ADDENDUM NO. 1
TO
MILLER ROAD INTERSECTION & CURVE RECONSTRUCTION PROJECT
PHASE 1 STP-5403(680) & PHASE 3 STP-5403(681)
COUNTY OF JEFFERSON, MISSOURI

August 11th, 2021

CDG PROJECT NO.
18101
DRAWING NO.
T-001

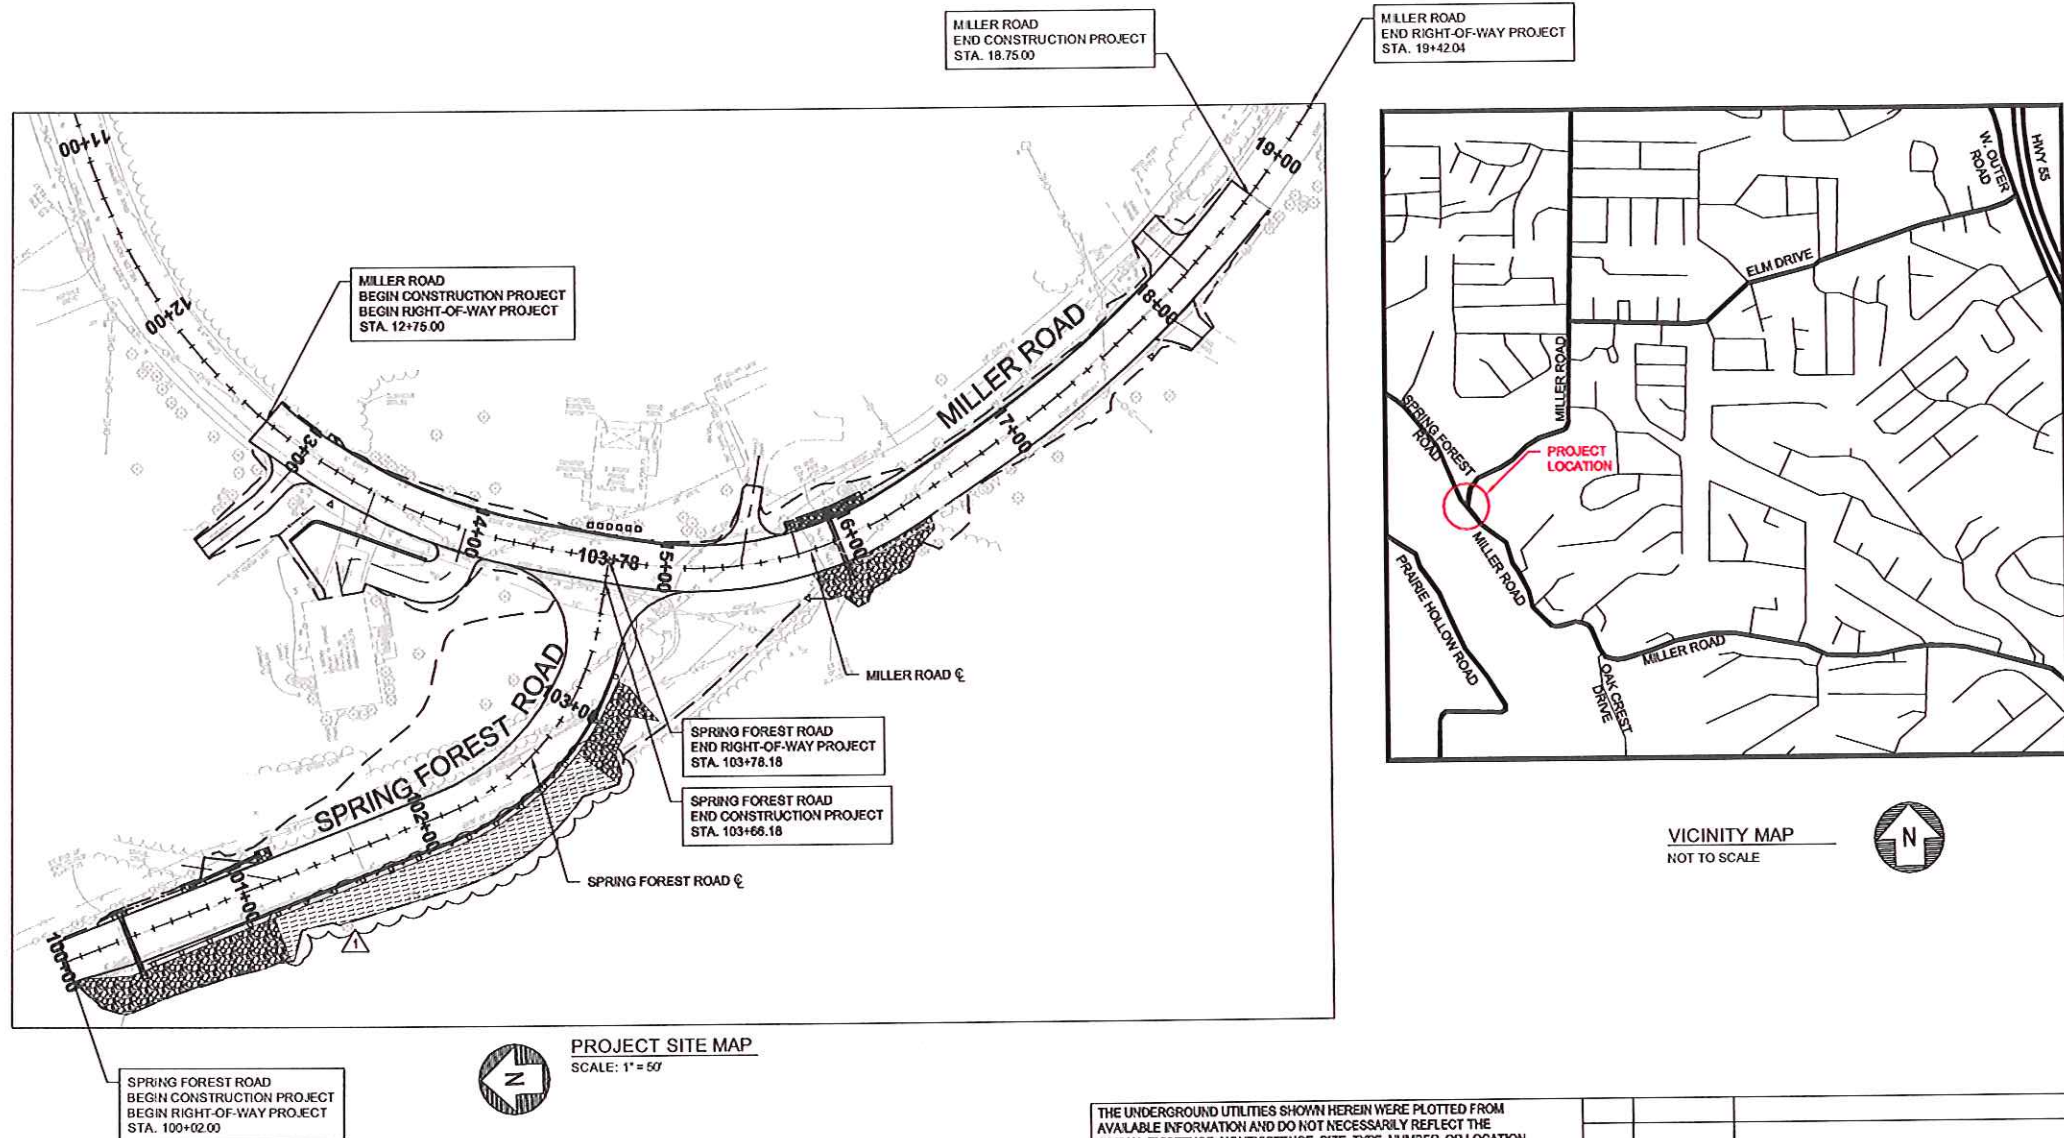
Remove plan sheet T-001 and replace with plans sheet T-001, revised 8/11/21 – Bid Addendum #1. Reason: revised the additional reinforcing crushed rock and slope face protection system on the slope of Spring Forrest Road.

CDG PROJECT NO.
18101
DRAWING NO.
T-006

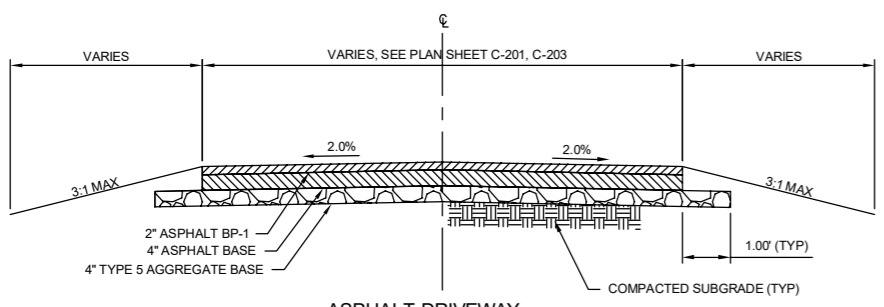
Remove plan sheet T-006 and replace with plans sheet T-006, revised 8/11/21 - 21 – Bid Addendum #1. Reason: revised item no. on the quantity summary 2B Table Continued.

CDG PROJECT NO.
18101
DRAWING NO.
C-102

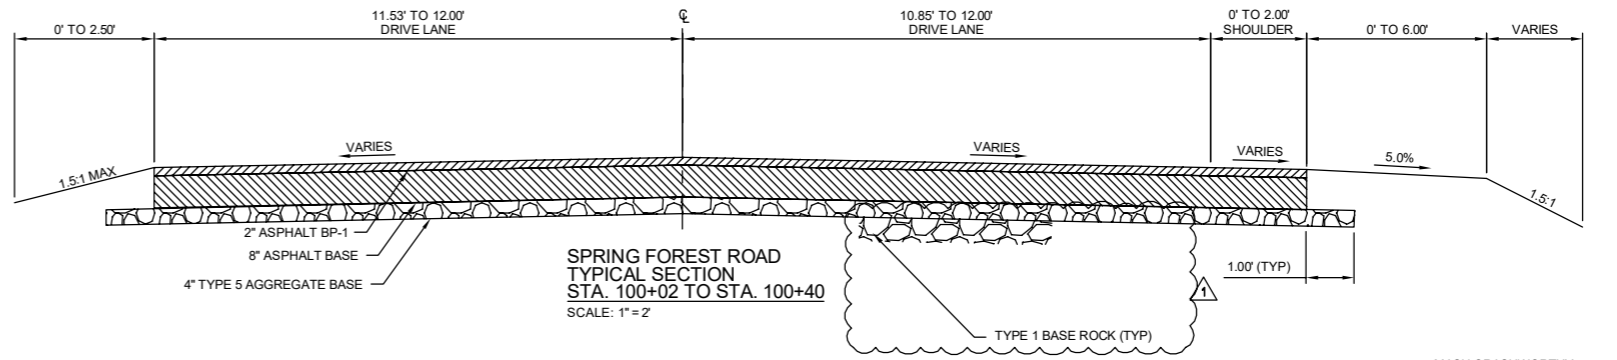
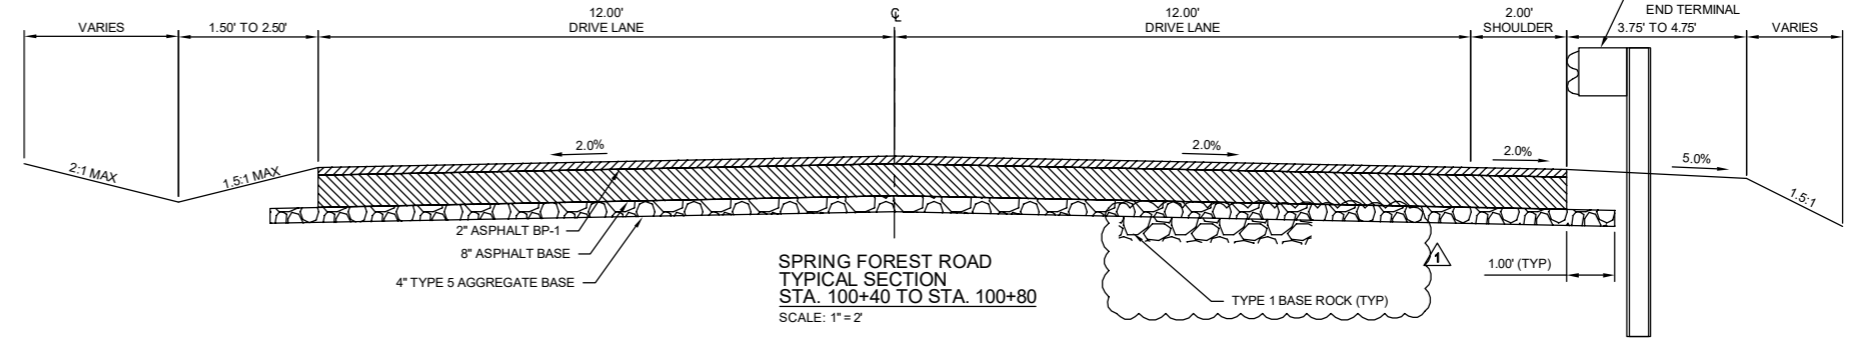
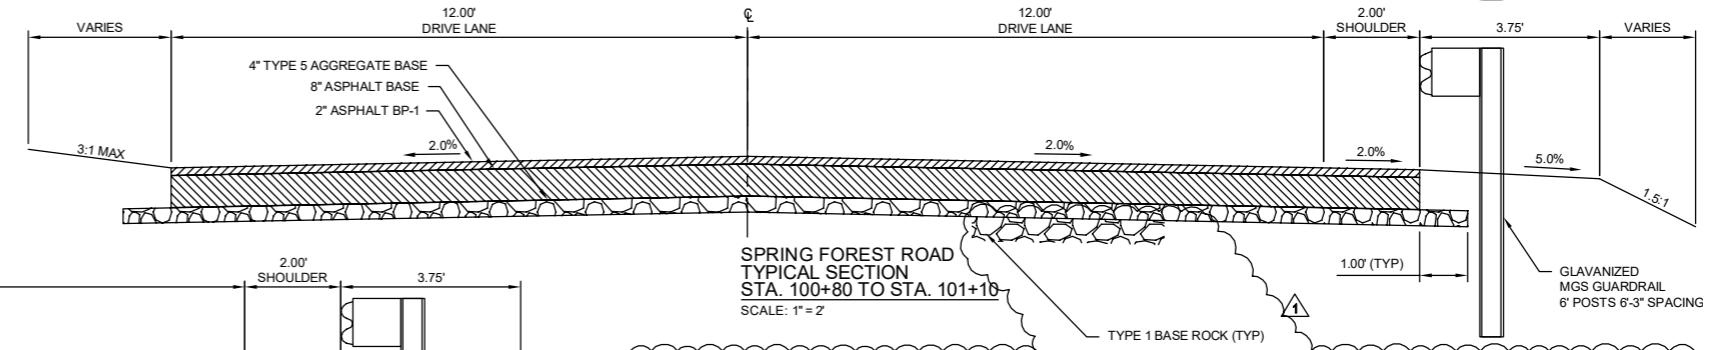
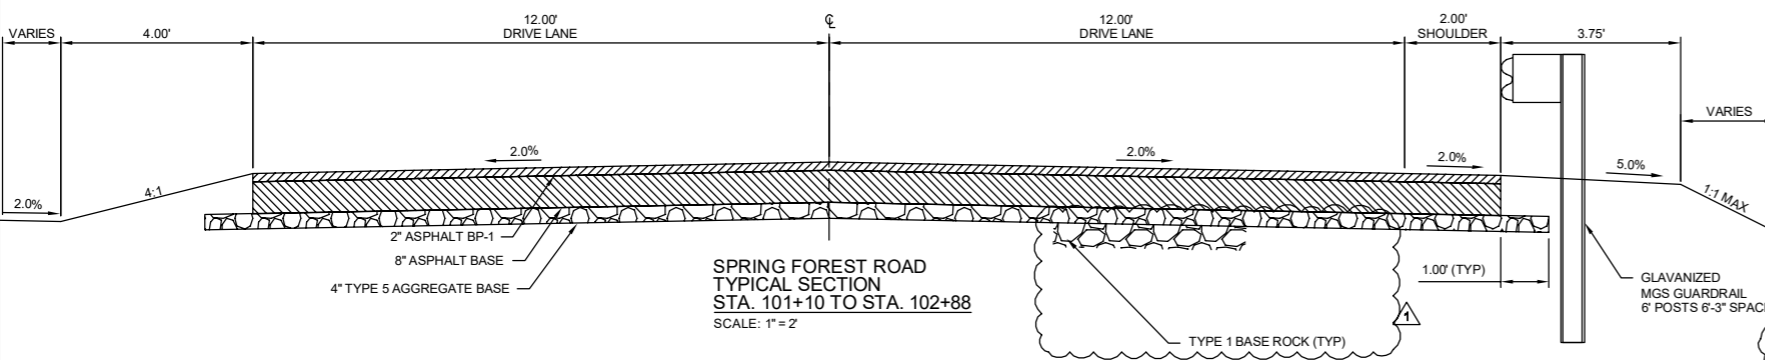
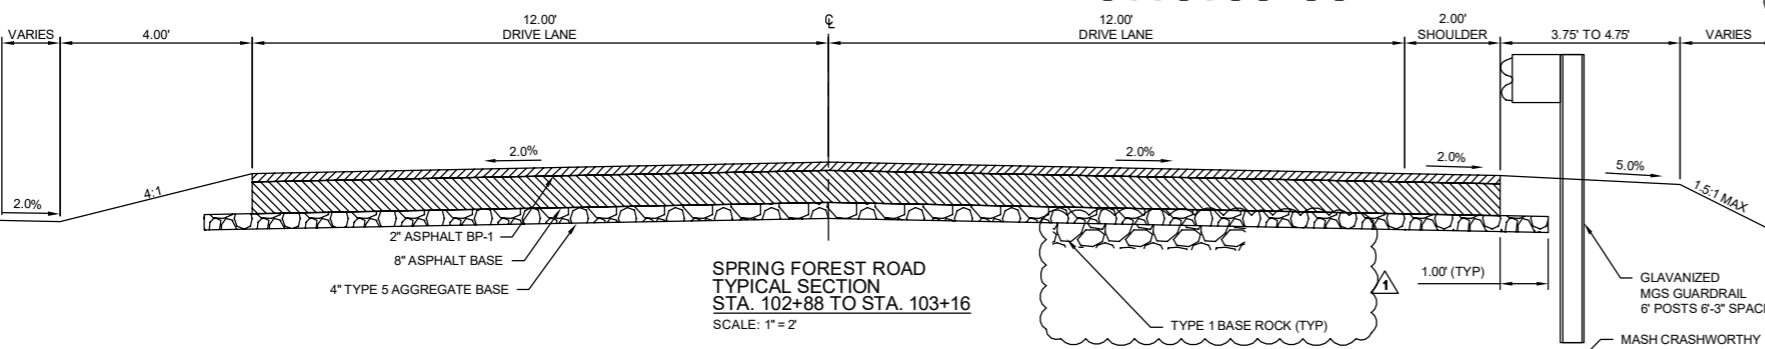
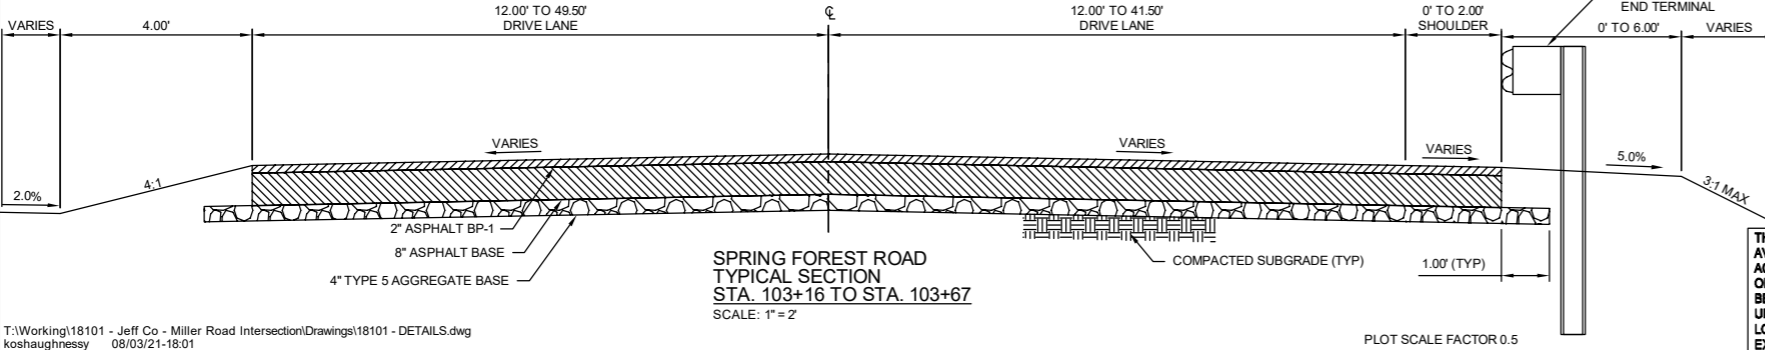
Remove plan sheet C-102 and replace with plans sheet C-102, revised 8/11/21 - 21 – Bid Addendum #1. Reason: Added the standard detail drawing for the reinforced rushed rock and slope face protection including notes.

REINFORCED CRUSHED ROCK AND SLOPE FACE PROTECTION NOTES:

1. REINFORCED CRUSHED ROCK SLOPE DETAIL PROVIDED FOR REFERENCE ONLY. THE CONTRACTOR IS RESPONSIBLE FOR FINAL DESIGN OF THE SLOPE PROTECTION SYSTEM.
2. COST OF THE REINFORCED CRUSHED ROCK SLOPE AND SLOPE FACE PROTECTION SYSTEM SHALL INCLUDE ALL ELEMENTS NECESSARY TO DESIGN AND CONSTRUCT THE SYSTEM, COMPLETE.

3. PROVIDE SLOPE FACE PROTECTION SYSTEM SUCH AS STRATA - StrataWeb®, PRESTO GEOSYSTEMS - GEOWEB®, OR TENSAR - Sierra Slope®
4. DESIGN REINFORCED CRUSHED ROCK SLOPE AND SLOPE FACE PROTECTION SYSTEM FOR STANDARD HIGHWAY LOADING.

5. FINAL DESIGN PLANS FOR THE REINFORCED CRUSHED ROCK AND SLOPE FACE PROTECTION SYSTEM TO BE SIGNED AND SEALED BY A PROFESSIONAL ENGINEER LICENSED IN THE STATE OF MISSOURI.

6. SEE SPECIFICATIONS FOR GEOTECHNICAL REPORT.
7. ALL SLOPES STEEPER THAN 1.5:1 SHALL BE REINFORCED CRUSHED ROCK WITH SLOPE FACE PROTECTION.
8. CONTRACTOR TO SUBMIT FINAL DESIGN PLANS TO JEFFERSON COUNTY FOR REVIEW PRIOR TO SYSTEM CONSTRUCTION.

CDG PROJECT NO.
 18101
 DRAWING NO.
 C-203

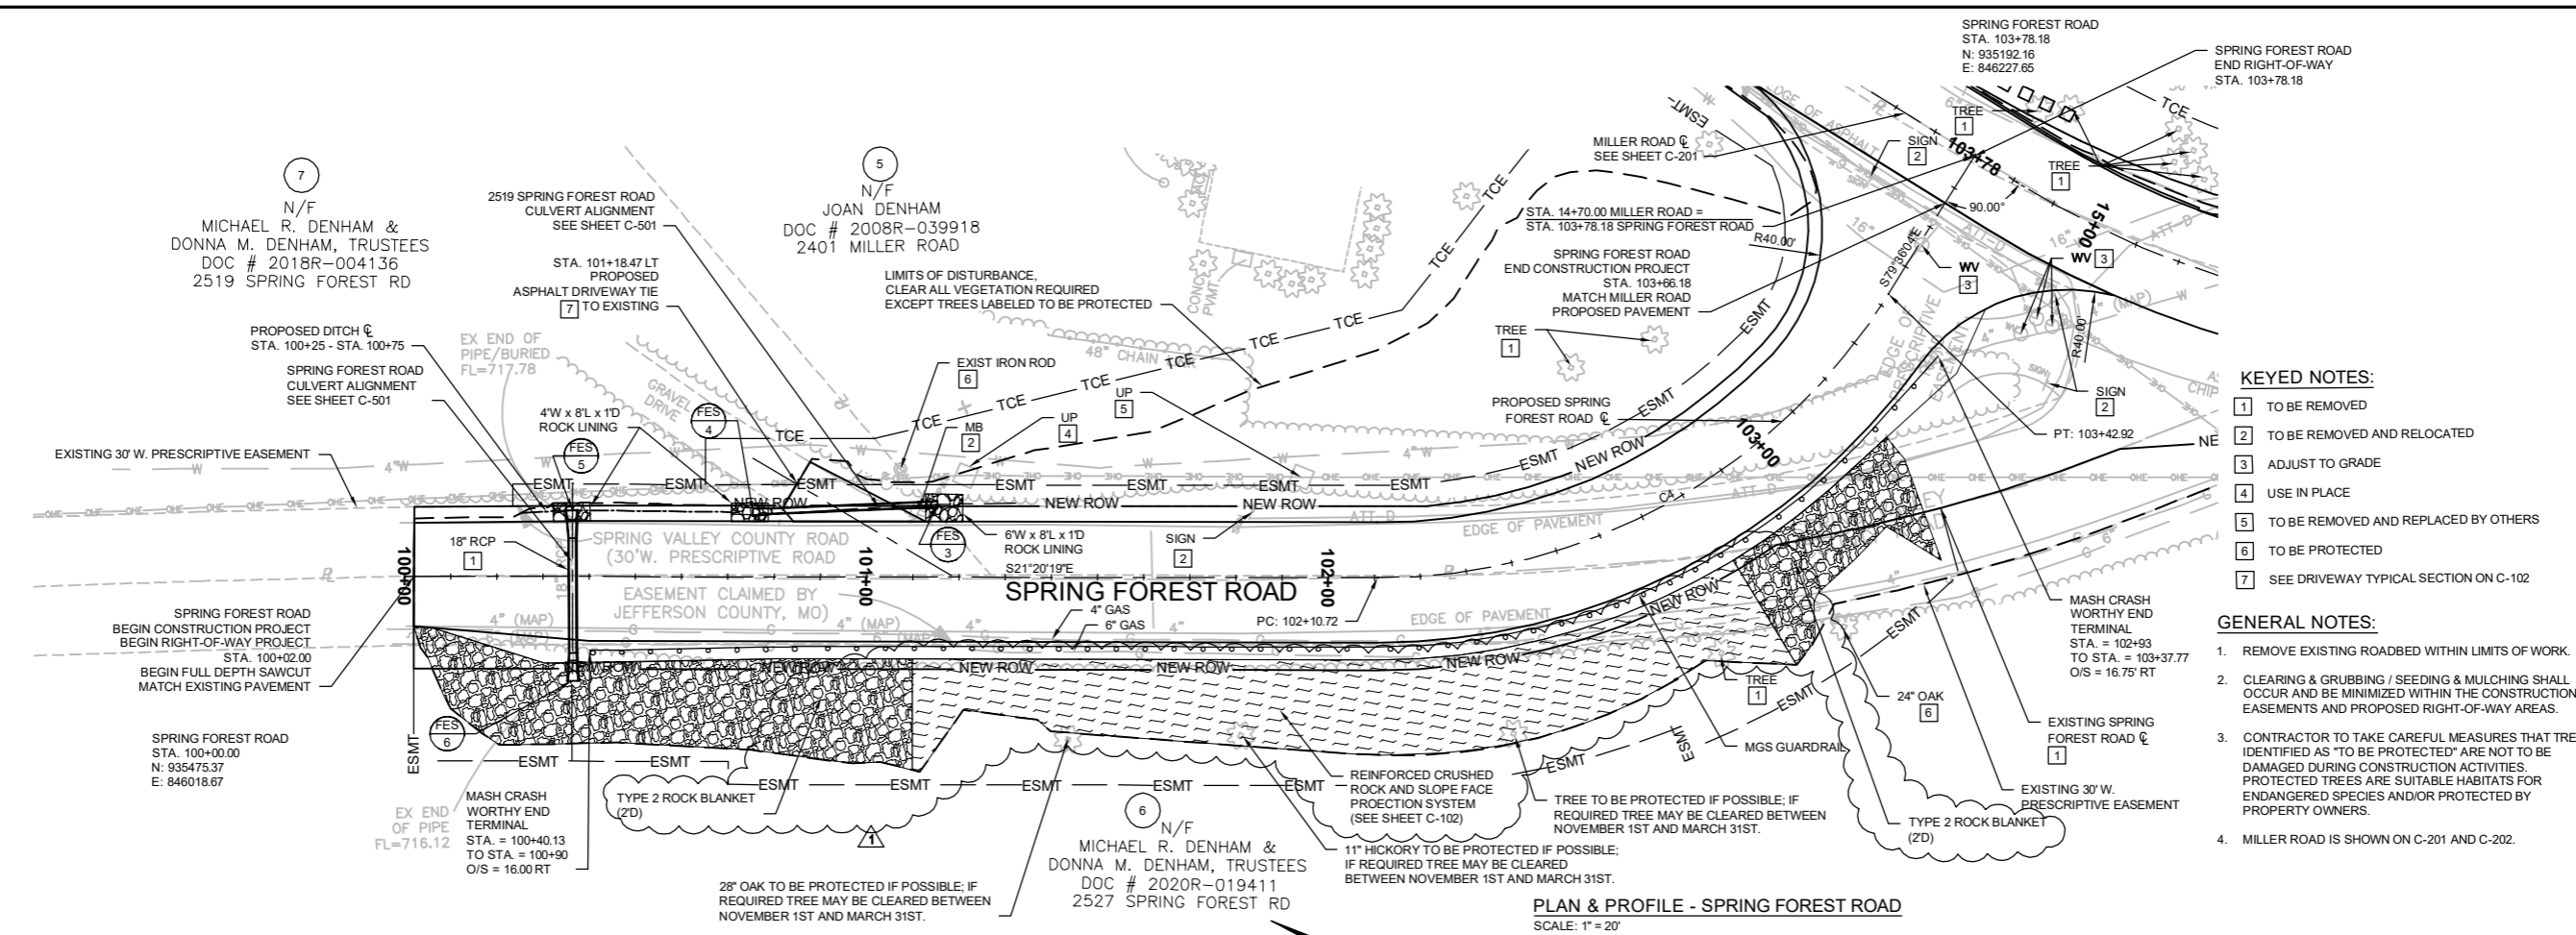
Remove plan sheet C-203 and replace with plans sheet C-203, revised 8/11/21 - 21 – Bid Addendum #1. Reason: the revised plans have the reinforced crushed rock and slope face protection system shown on the plans with the areas of the Type 2 Rock Blanket.
